SUBJECT: ALTERNATE TUBE PLUGGING LIMITS

SUBJECT: MEETING SUMMARY OF MARCH 10, 1992

CONCERNS REGARDING THE ALTERNATE PLUGGING CRITERIA

Figure 17 - Results from NRC Steam Generator Tube Integrity Program -
Equations for Curves and Similar Plots Reported in NUREG/CR-0718

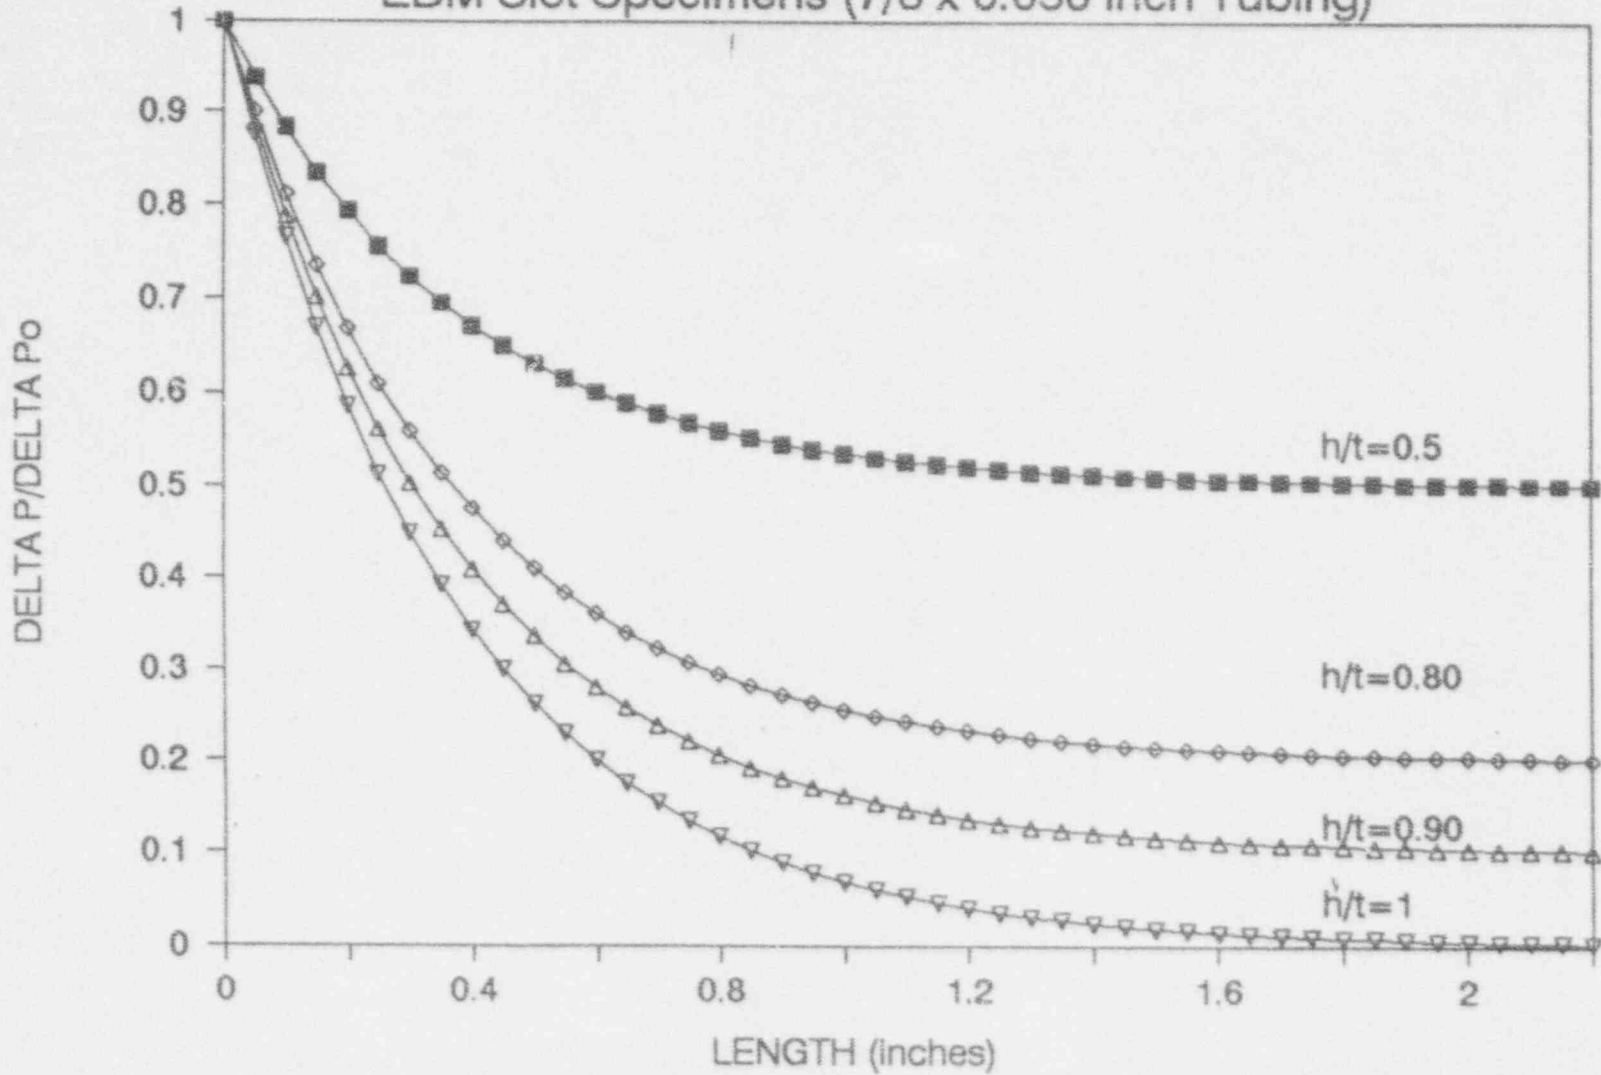
Points of interest are that longer (above 0.8") through-wall flaws exhibit low burst pressures and even relatively short but deeper flaws also exhibit low burst pressures. Figure 17 shows for example that a tube with 0.4-inch long through-wall flaw can withstand about 3,500 PSI pressure but a 0.8-inch long through-wall flaw would withstand only about 1200 PSI pressure. A tube with a 0.5-inch long flaw at 50 percent through-wall penetration would withstand about 6,500 PSI pressure at 80 percent through-wall, 4,000 PSI at 90 percent through-wall, 3,400 PSI and the 0.5-inch long flaw, 100 percent through-wall, would withstand approximately 2,500 PSI.

The NRC tube integrity results indicate that tubes with short flaws exhibit more strength than tubes with longer flaws of the same depth, also tubes with shallow flaws can withstand considerably more pressure. Figure 17 shows plots from an empirical equation derived from the data for EDM notches and validated by testing of stress corrosion cracks. It is not surprising that tubes removed from service have exhibited high burst pressures; this can be predicted for short through-wall flaws or for other reasonably deep fi....

Figure 14 - Data taken from various sources, see NUREG/CR-2336 and NUREG/CR-5117

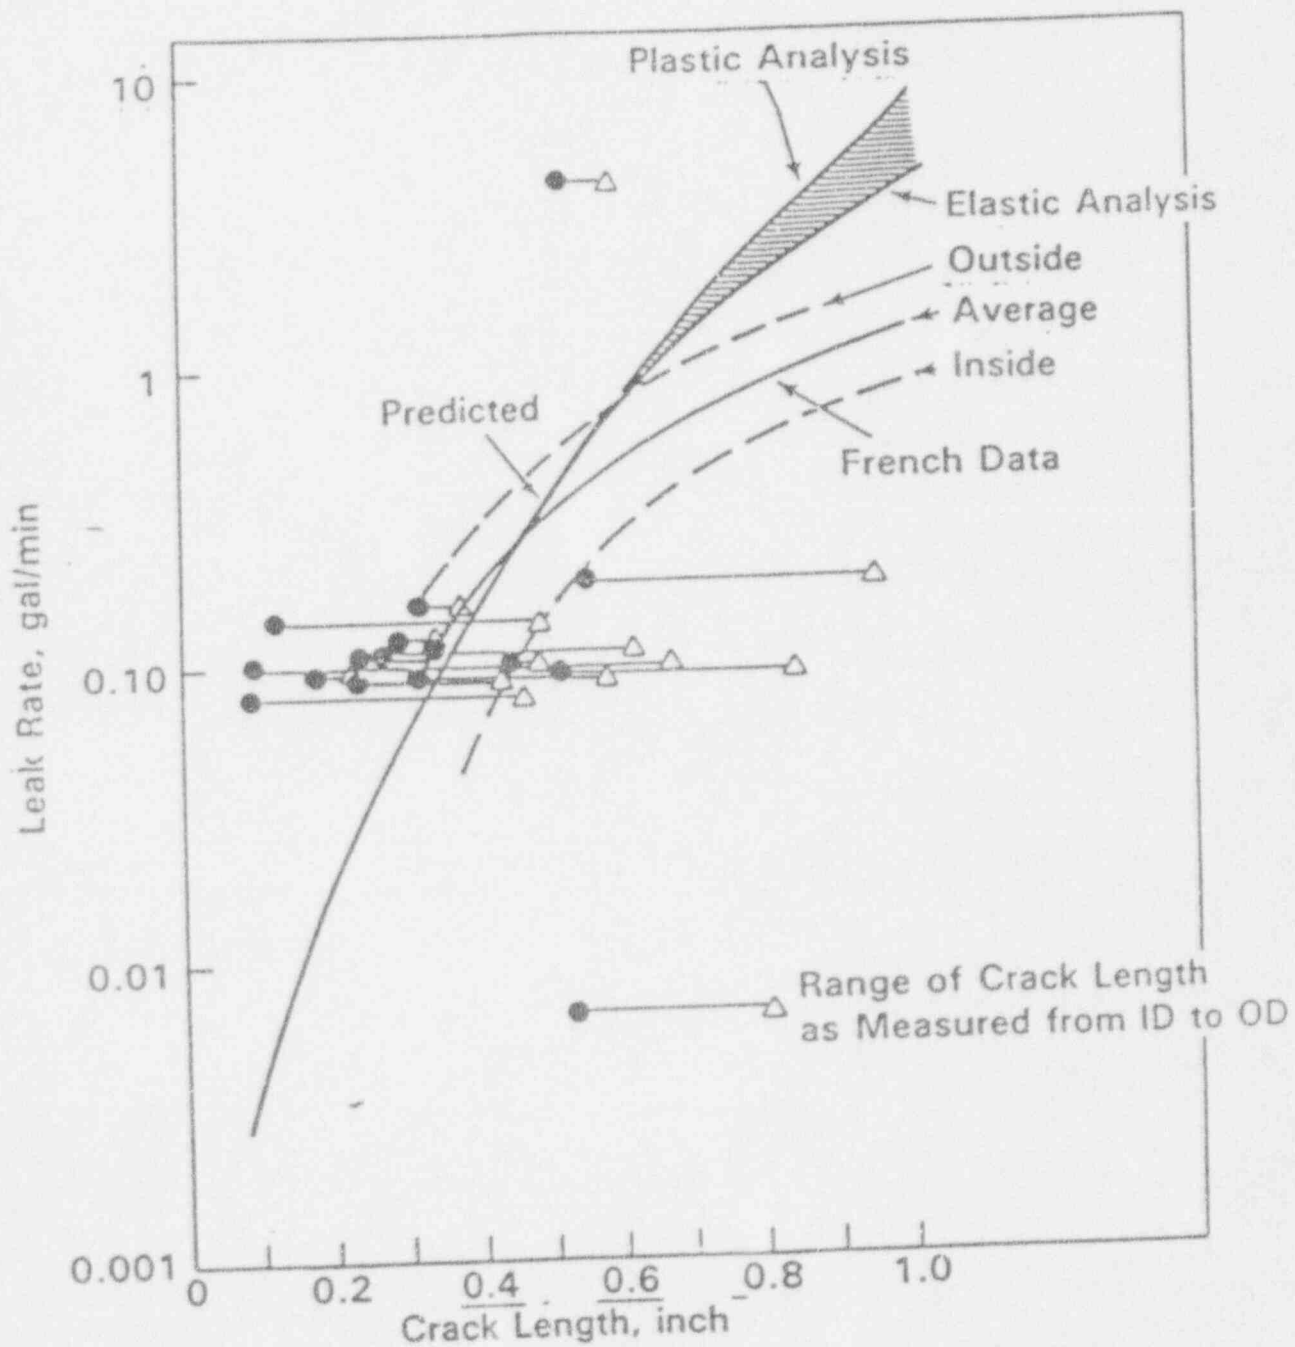
Assuming for a moment that a) through wall cracks can be reliably detected and their length accurately sized b) the amount of crack growth, any changes in cracking mechanism and morphology, and growth outside of original zones can be reliably predicted and c) particular cracks will not approach critical sizes during the next operating cycle and are left in service, then these cracks must be monitored during operation to assure that they will not approach critical size. To accomplish this monitoring, leak rate measurements and specifications are established. Unfortunately, for the types of cracks of interest, correlations of leak rates to crack sizes and measured leak rates vs. predicted leak rates (from fluid flow and fracture mechanics models) show approximately two orders of magnitude variabilities, Figures 14 and 15.
